**Public Hearing for PUD Amendment – Lot 9,
Southport East Replat Six – Galaxy Ventures, LLC**

RECOMMENDATION REPORT

CASE NUMBER: 2016-PUD-05

RE: PUD Site Plan - Initial Review
Lot 9, Southport East Replat Six

Scott P. Heaney, AIA
Architect, Associate

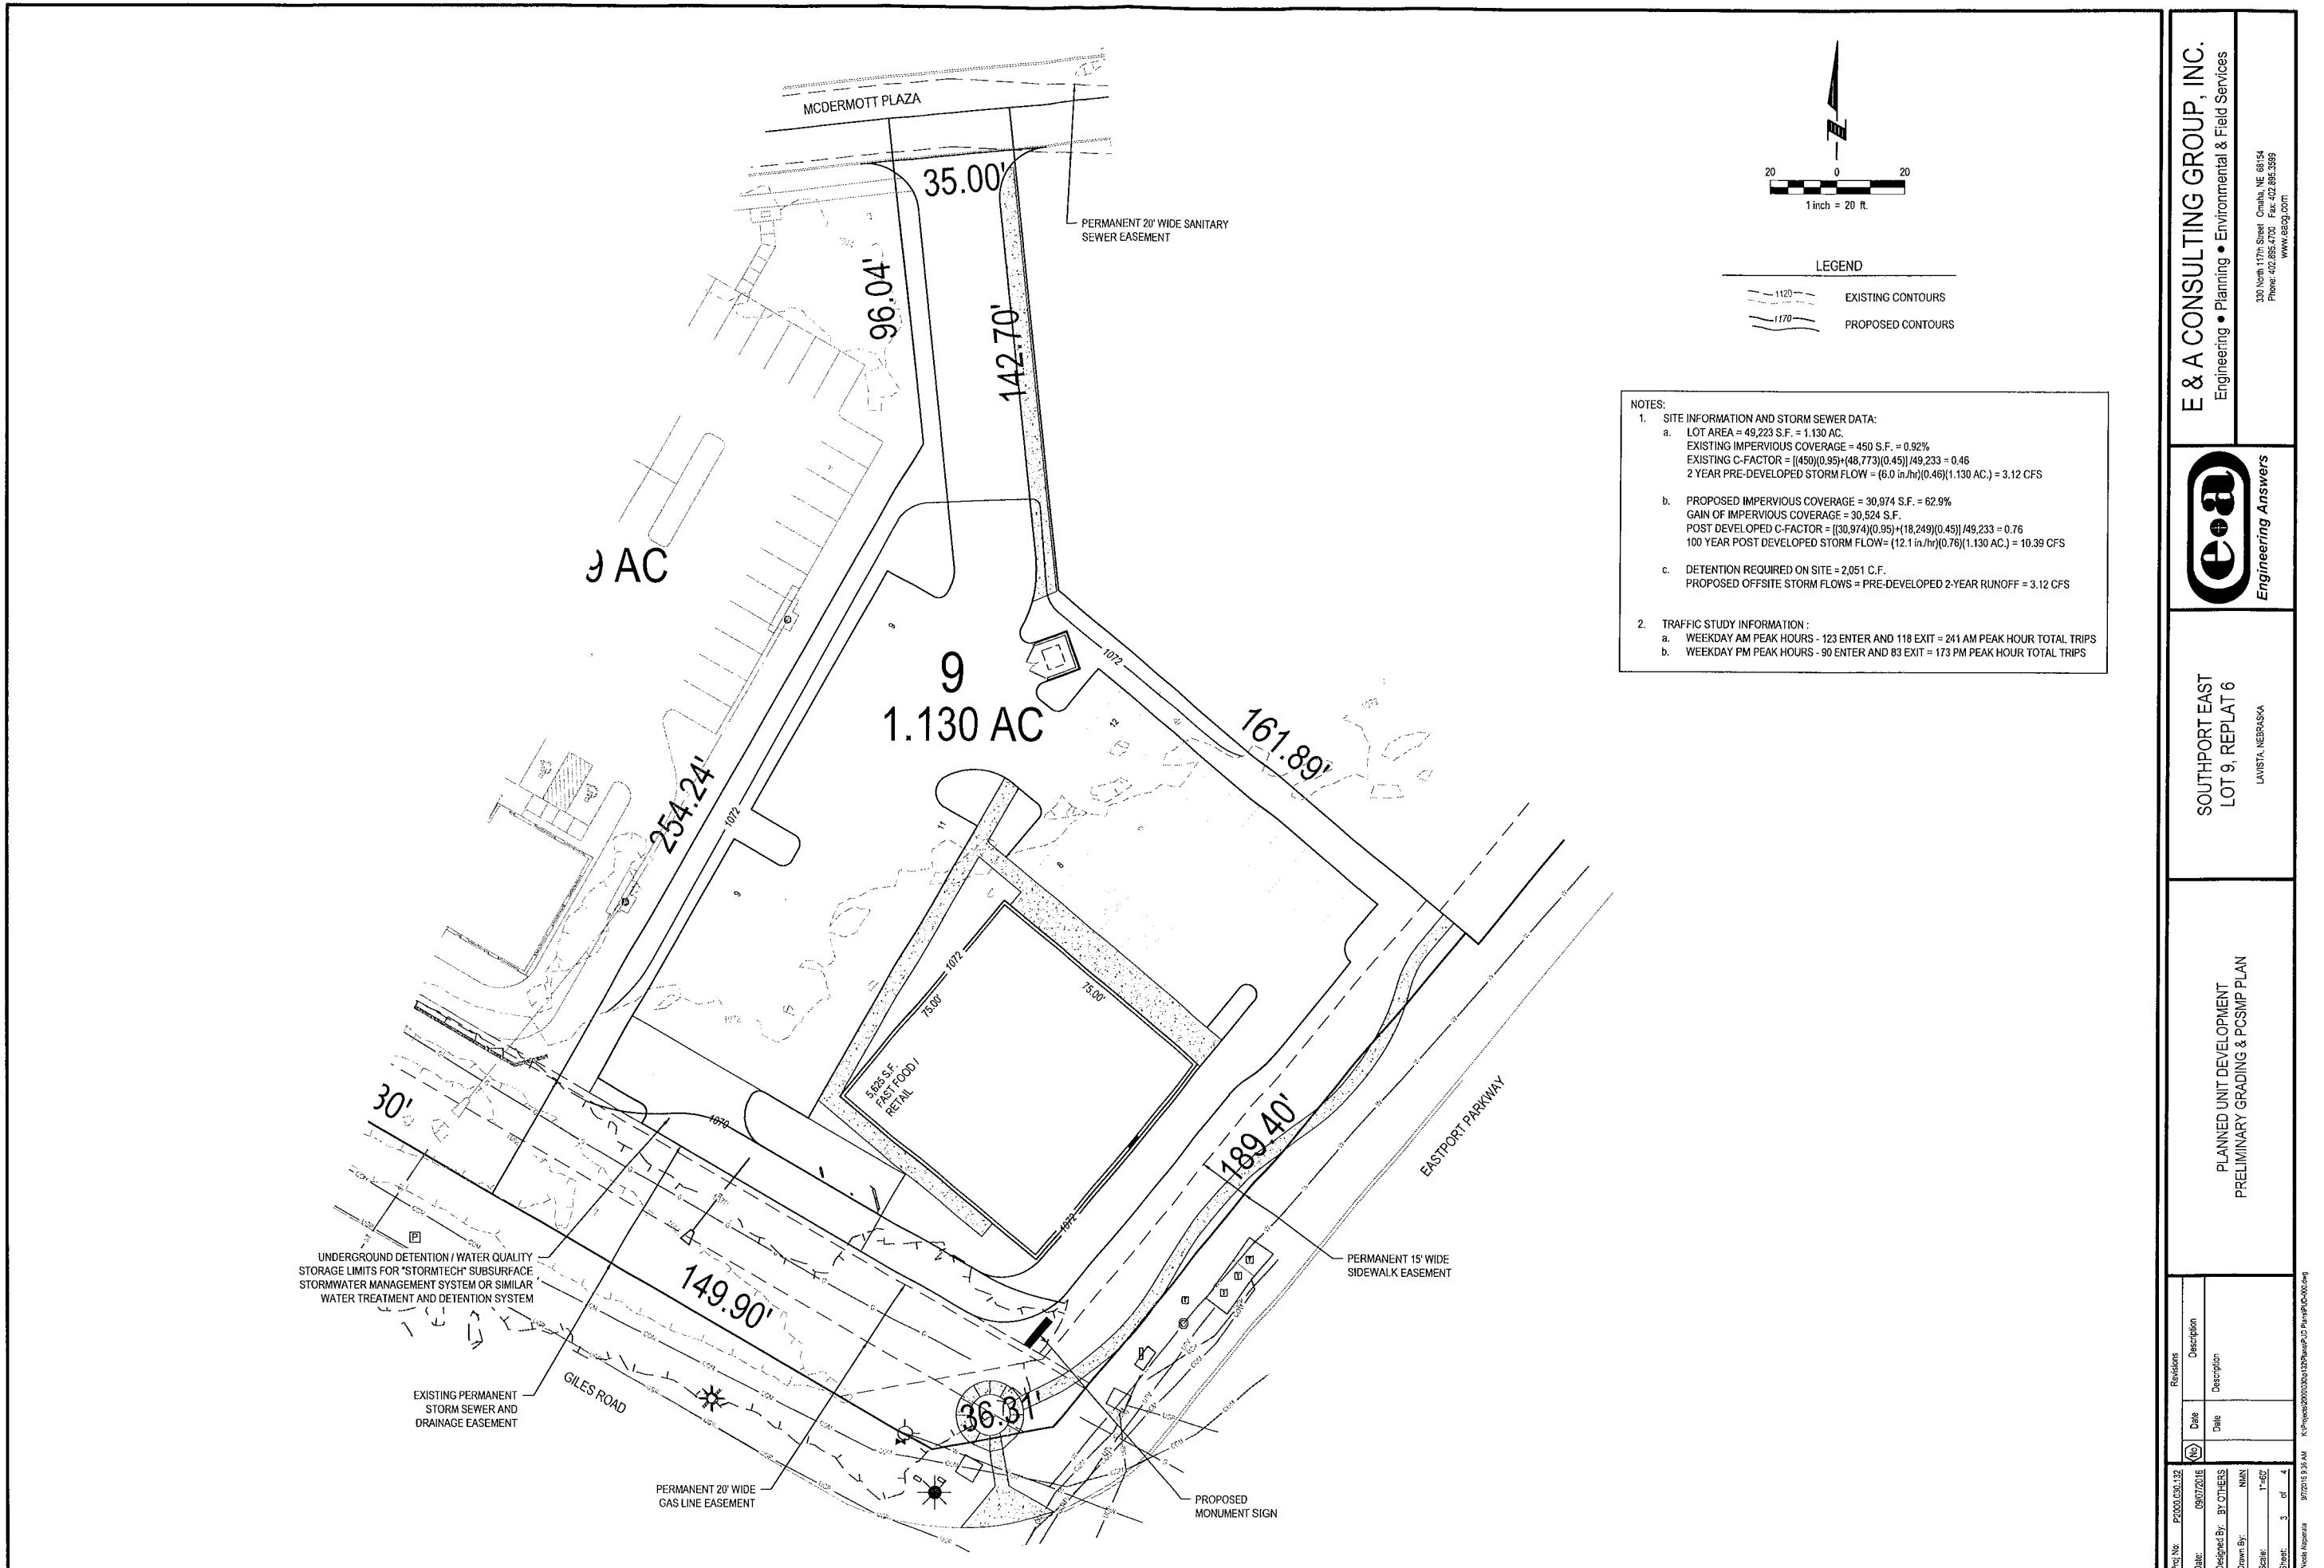
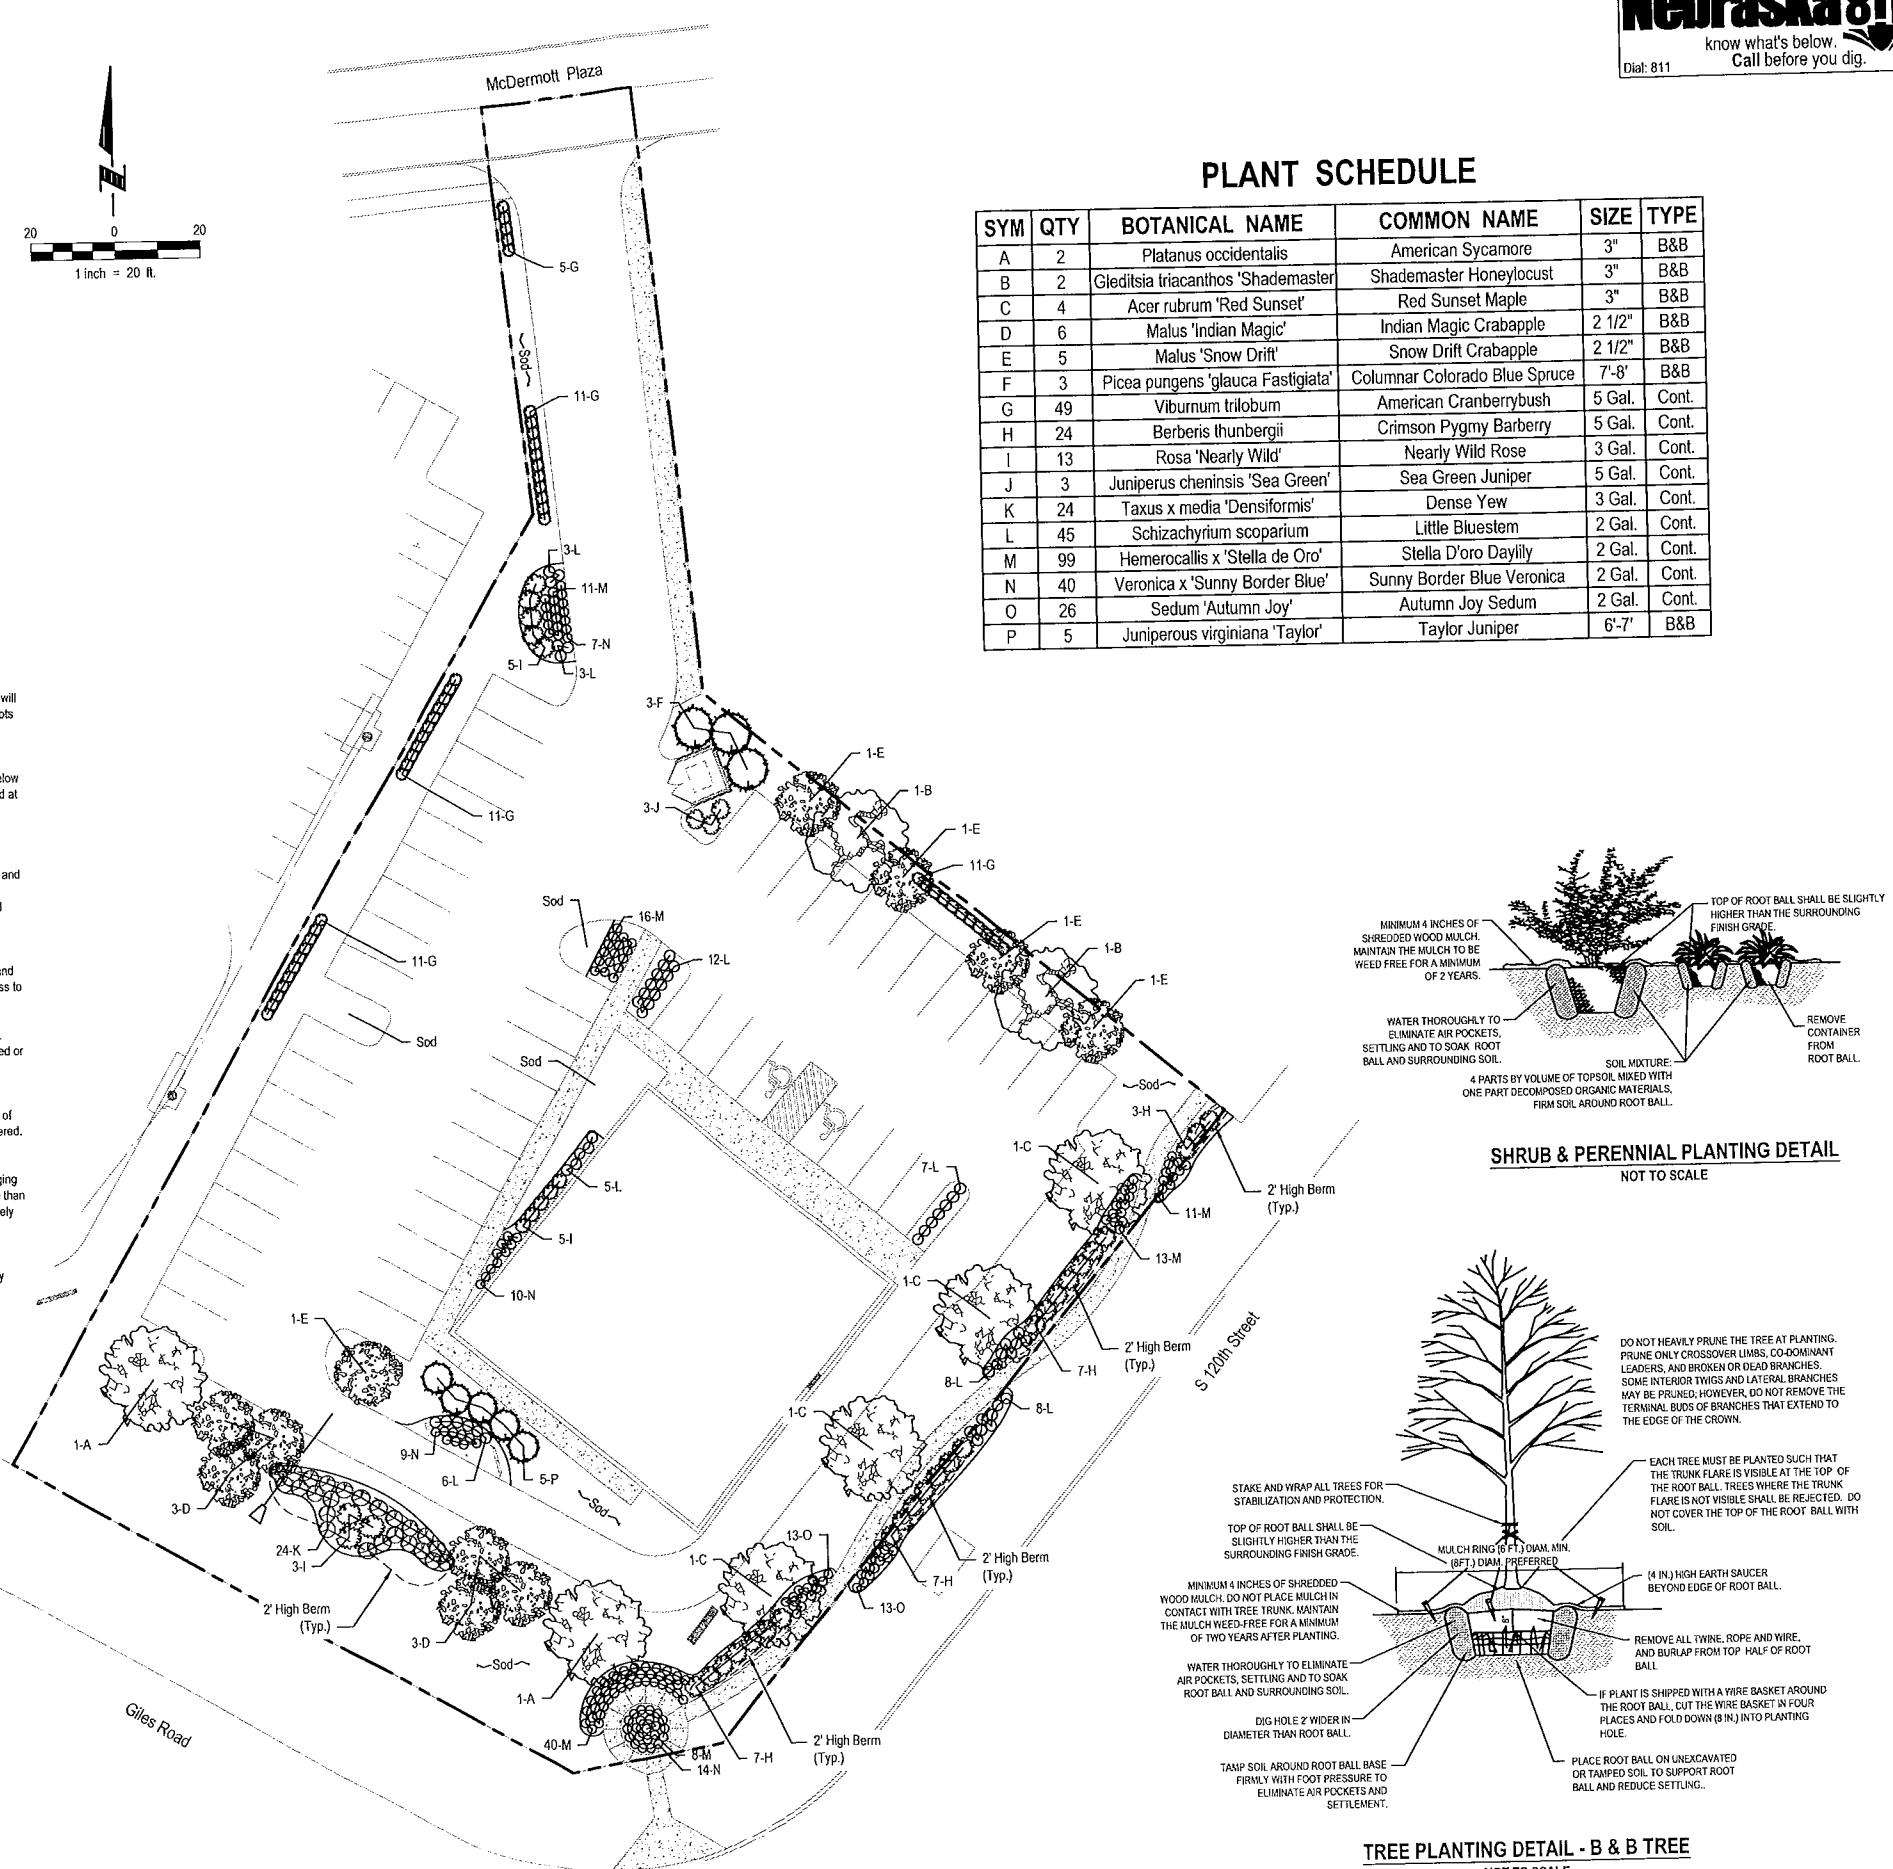
- a. Plant Schedule - Please refer again to the Southport Guidelines, Appendix F and G. for approved Street Tree and Plant Lists. The majority of the proposed selections are non-compliant. Note that we have recently interpreted the Guidelines to allow grasses, even though not included in the required Plant List, to be consistent with what has been previously installed in both Southport East and West. We will allow Sunset Red Maples along Eastport Parkway (old 120th Street) whereas the guidelines call for an Autumn Purple Ash. American National Bank, directly to the southeast, utilized Maples as well so they would match.

- b. The Guidelines don't include Colorado Blue Spruce, although there are existing conifers on the Runza and Burger King sites adjacent to Lot #9. We will allow the spruces because they are screening the view of the trash enclosure from McDermott Plaza, which is desirable.

- c. Plant sizes meet or exceed the minimums. The Sea Green Juniper is 2 gallons to small. The Dense Yew is using a different measurement than the Guidelines (3 Gal v. 18"-24"), which may be similar in size, but needs to be verified.

- d. Please review and resubmit the Landscape Plan with revised selections and designations.

1. Comments #1 – 2 – We have addressed the comments from the City's third-party architect and revised the Landscape Plan. We understand that Design review approval, through the Southport East Design Guidelines, will need to be achieved before building permit submittal.
